# BURLINGTON ENVIRONMENTAL

Re: Submittals Required by Pier 91 Permit Appeal Resolution

**Attachment 1**

**Revised Design Drawing for Tanks 2705-2708**

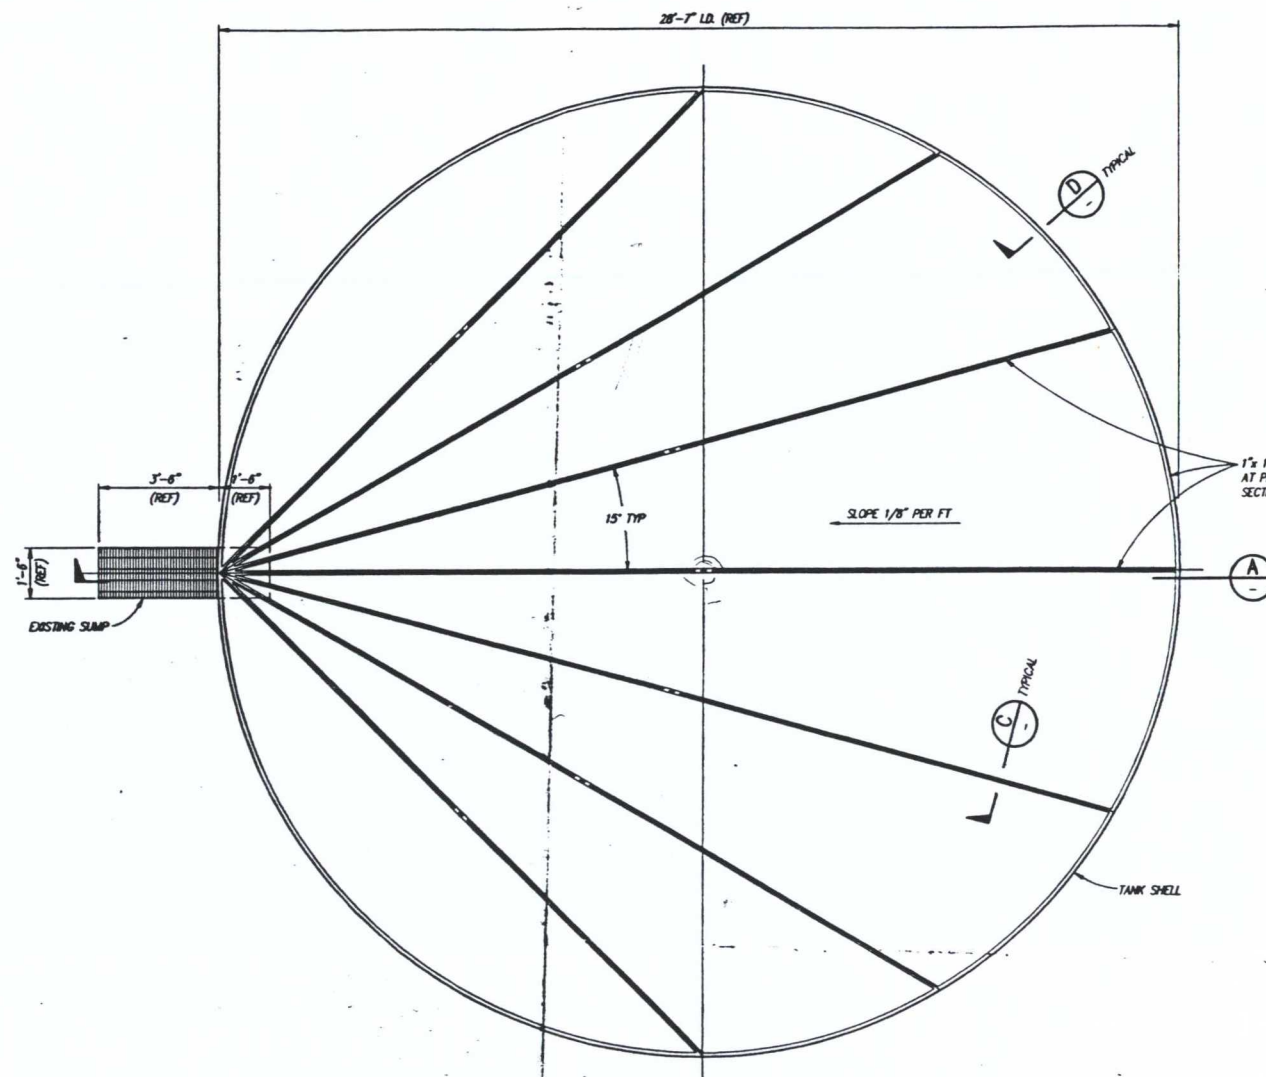
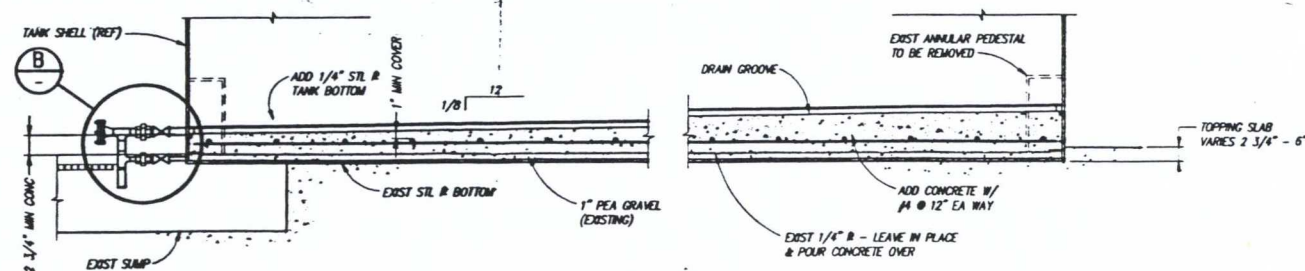
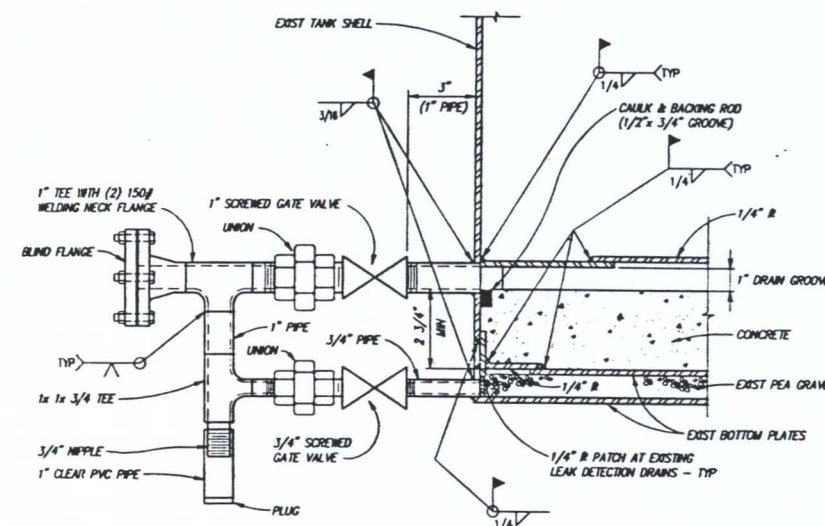
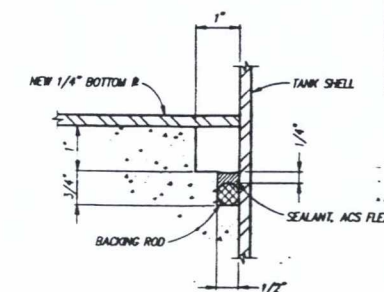
- Attachment 1: revised design drawings for the leak detection systems for tanks 2705-2708 (Permit Condition IV.A.5).
- Attachment 2: revised facility inspection plan specifying procedures taken to determine whether liquid detected in the leak detection receptacle devices for tanks 2705-2708 is condensation or leaked material (Permit Condition IV.A.6).
- Attachment 3: revised closure plan specifying the procedures for analysis and/or decontamination or disposal of the leak detection systems for tanks 2705-2708 (Permit Condition IV.A.7).

NOTE:  
SEAL ANY PENETRATION INTO TANK FOR CONSTRUCTION PURPOSES  
WITH 1/4" R AND FULL PENETRATION BUTT WELDED INTO PLACE.
